SUBJECT: DRAINAGE OF LOT 7, BLOCK 2, FOUR HILLS VILLAGE, UNIT 1
ACROSS THE WINTERWOOD PARK SUBDIVISION

SUBJECT: Corrections and changes made to the plat and drainage plan of Winterwood Park with respect to comments made by the Assistant City Engineer/Hydrology in letter dated June 6, 1980.

TO: R. S. Heller, City Engineer
THRU: Charles M. Easterling, Princ. Asst. City Eng./Hydrology
FROM: Bruno Conegliano, Civil Engineer
SUBJECT: DRAINAGE OF LOT 7, BLOCK 2, FOUR HILLS VILLAGE UNIT 1

ENVIRONMENTAL PLANNING COMMISSION
May 17, 1979
Z-78-138

RUNDOWN REVISION
BETWEEN LOTS 4 AND 5
BLOCK 1
WINTERWOOD PARK
ALBUQUERQUE, NEW MEXICO
SUPPLEMENT TO DETAILS ON SHEET 5 OF 5
CITY DRAWING NO. C-29-193

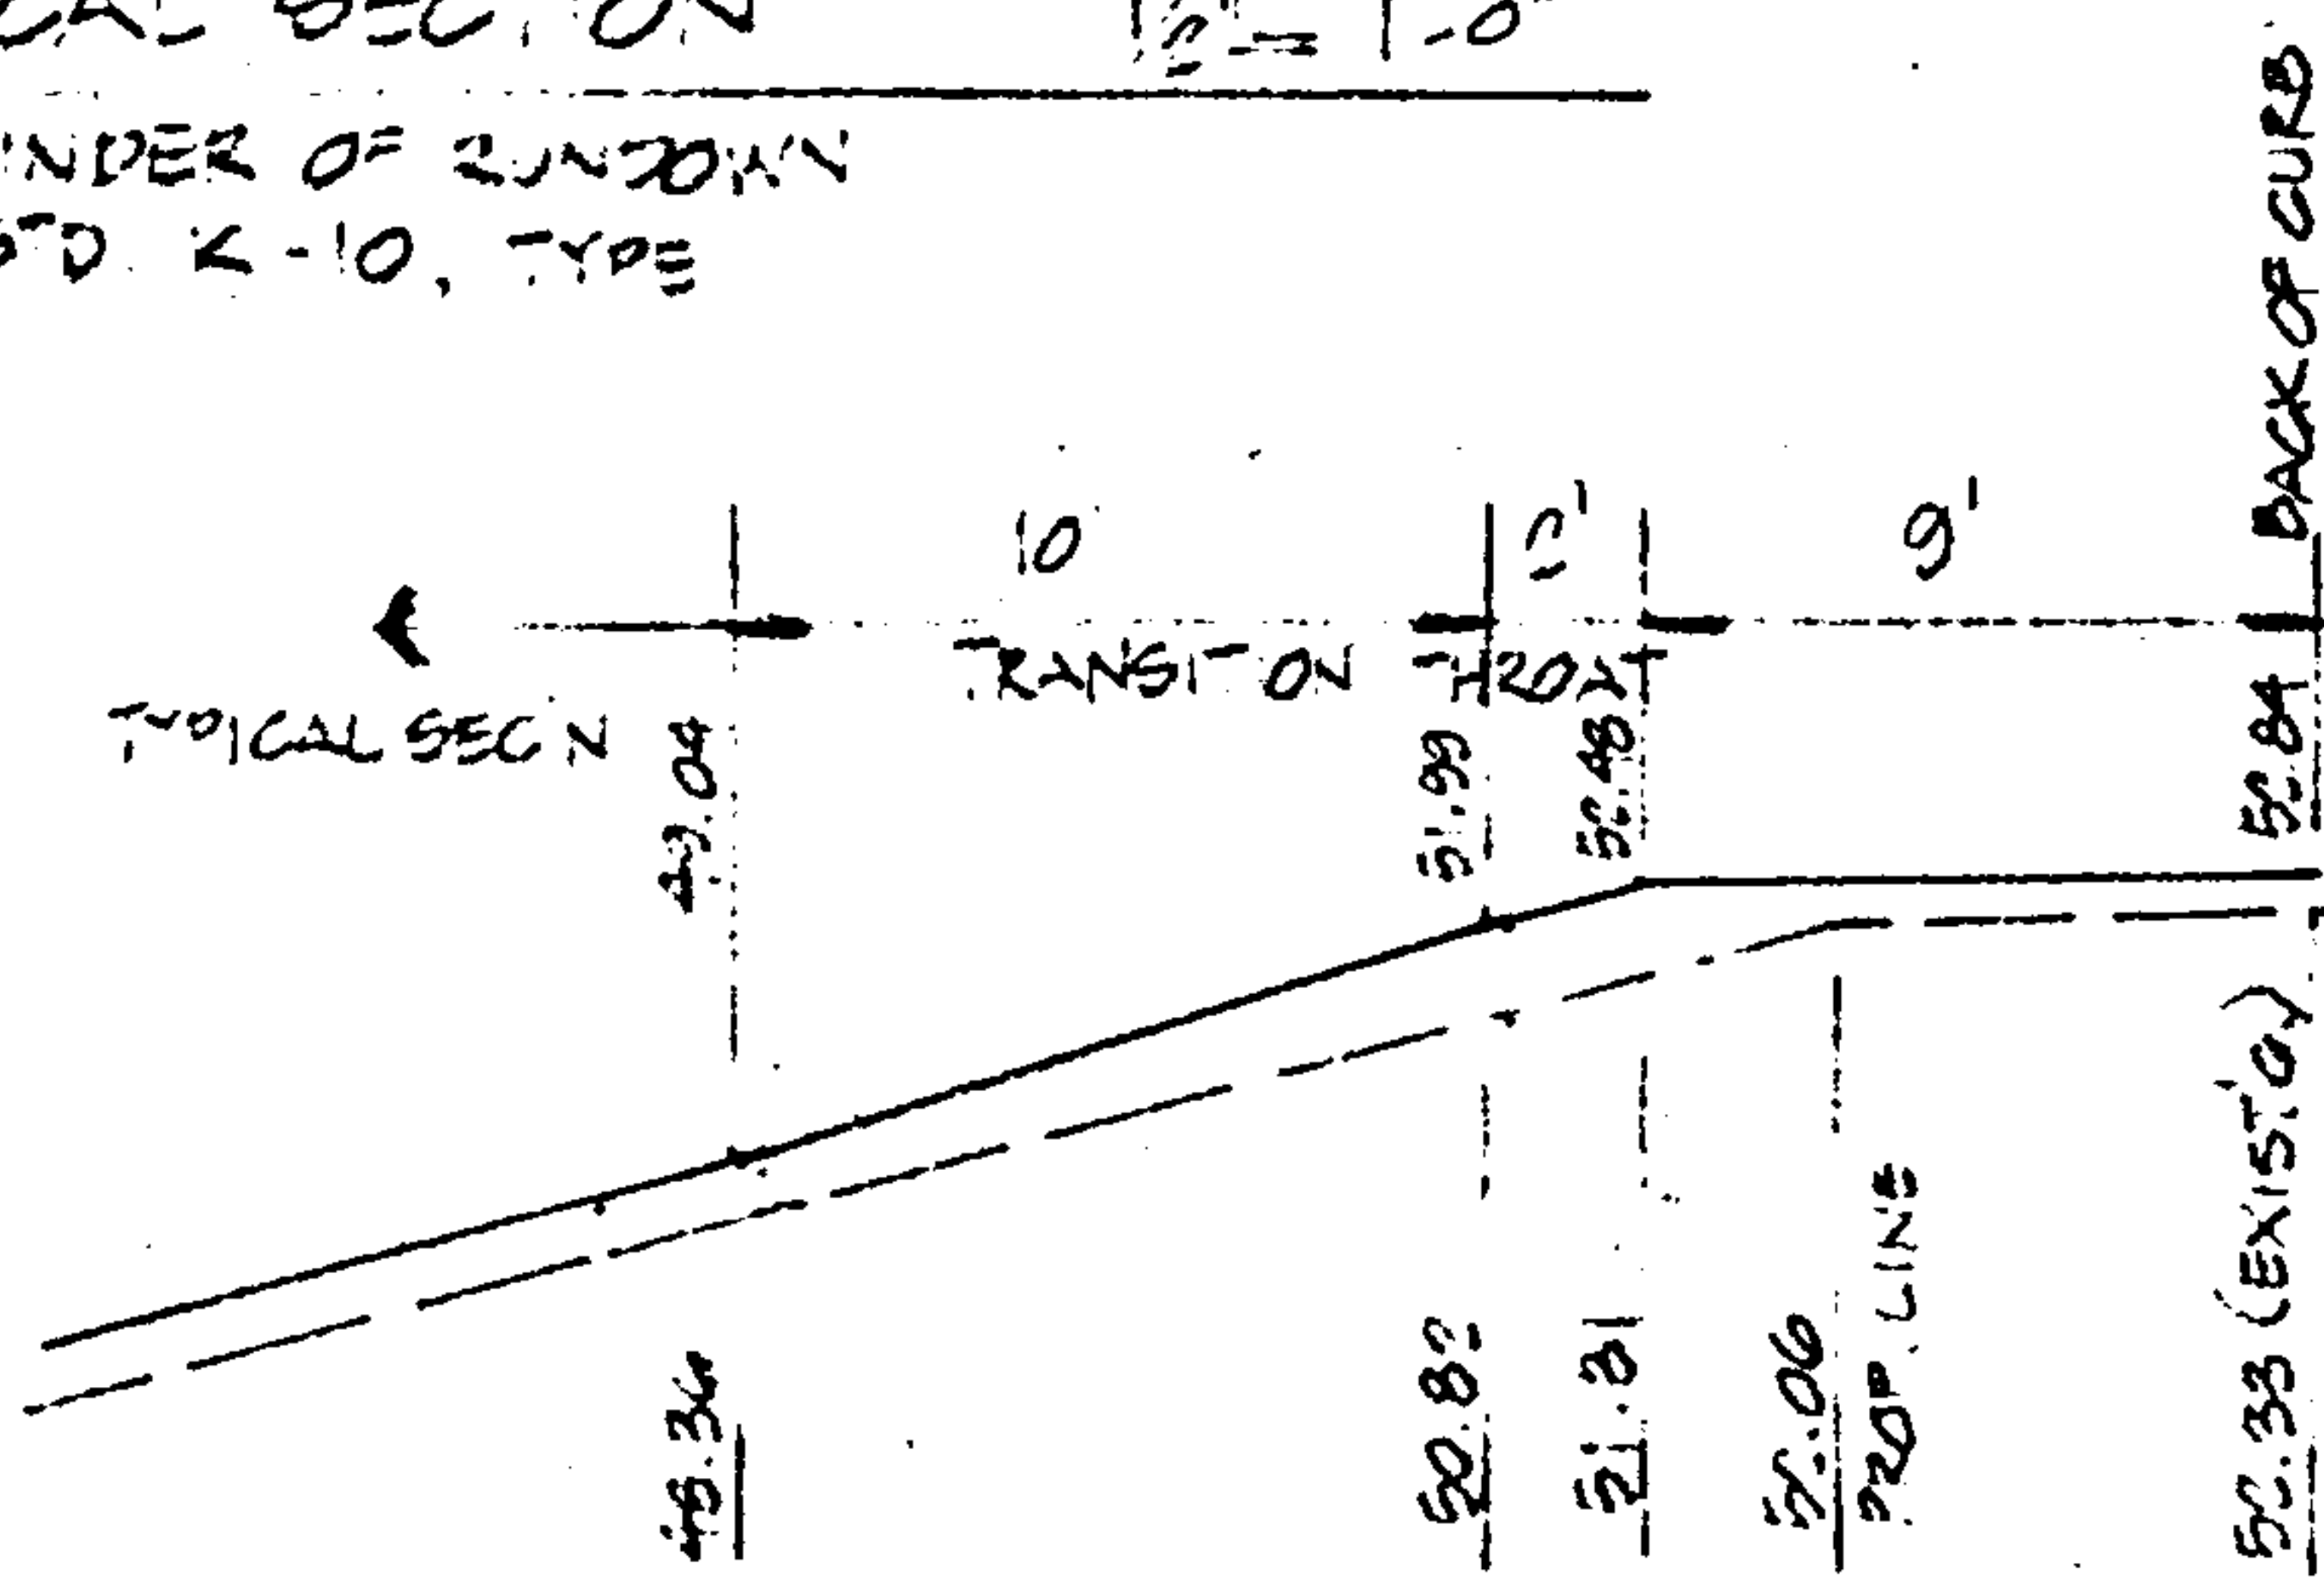
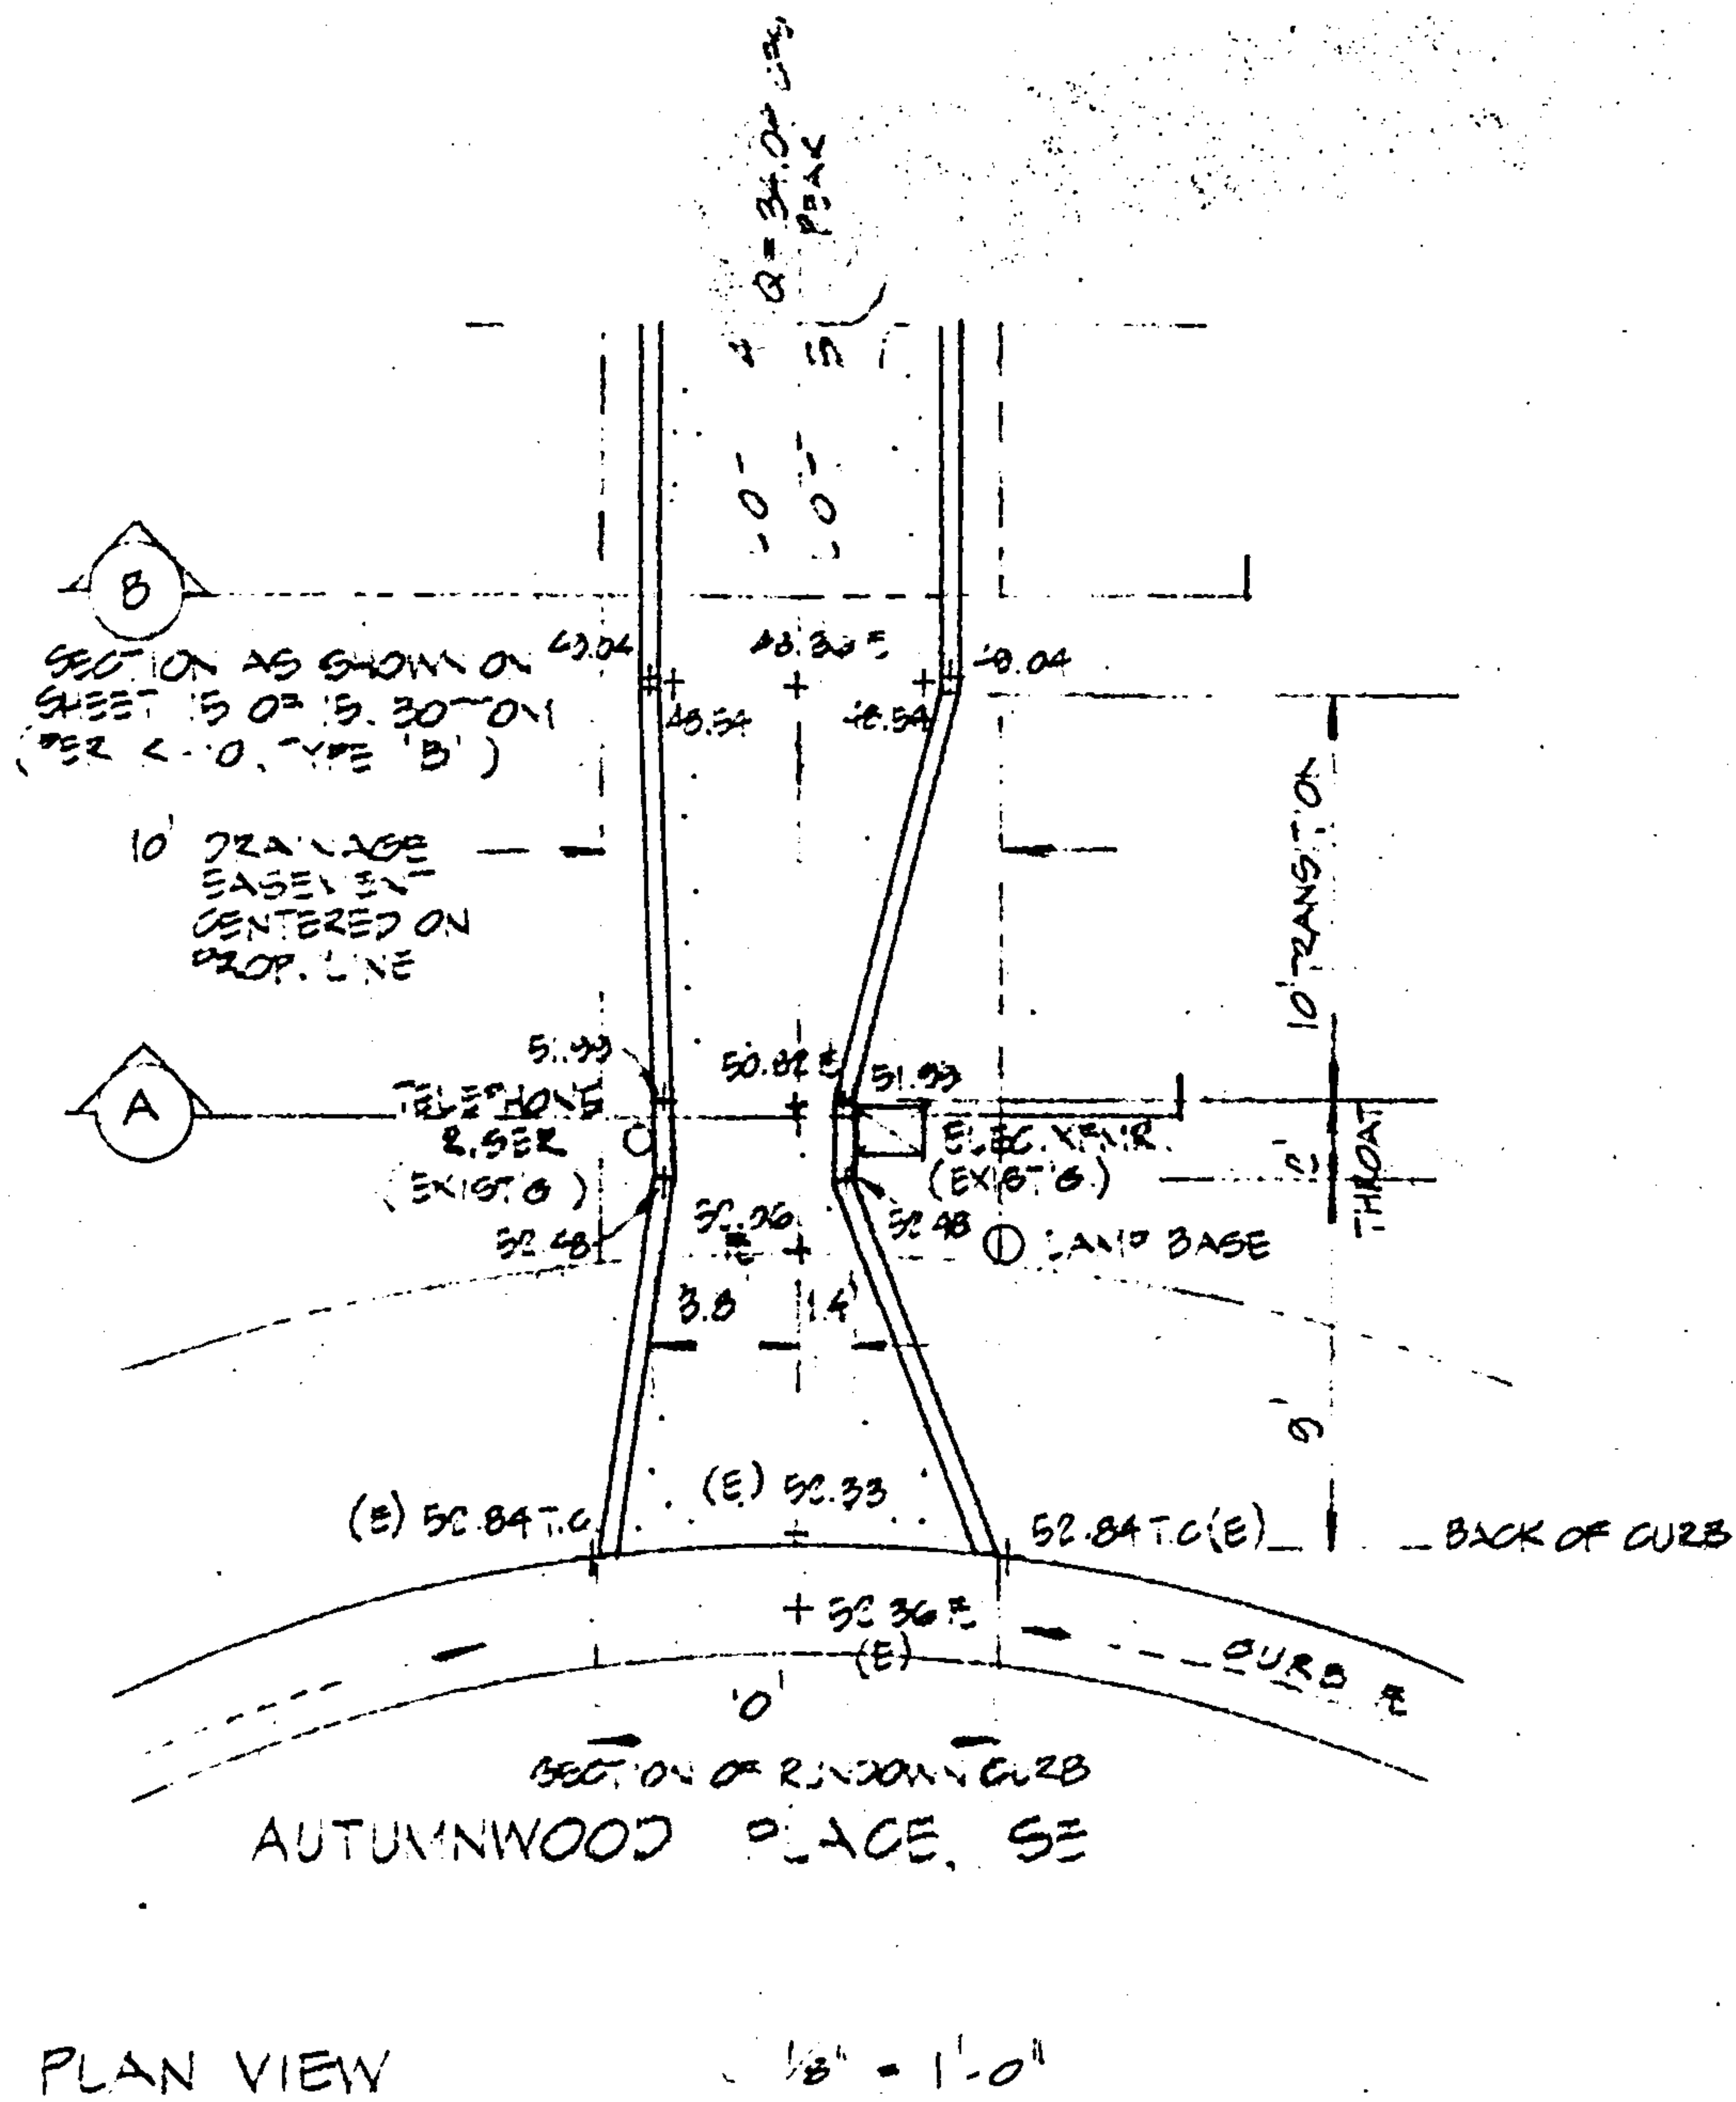
(B) TYPICAL SECTION
REMAINDER OF RUNDOWN
PER STD. K-10, TYPE
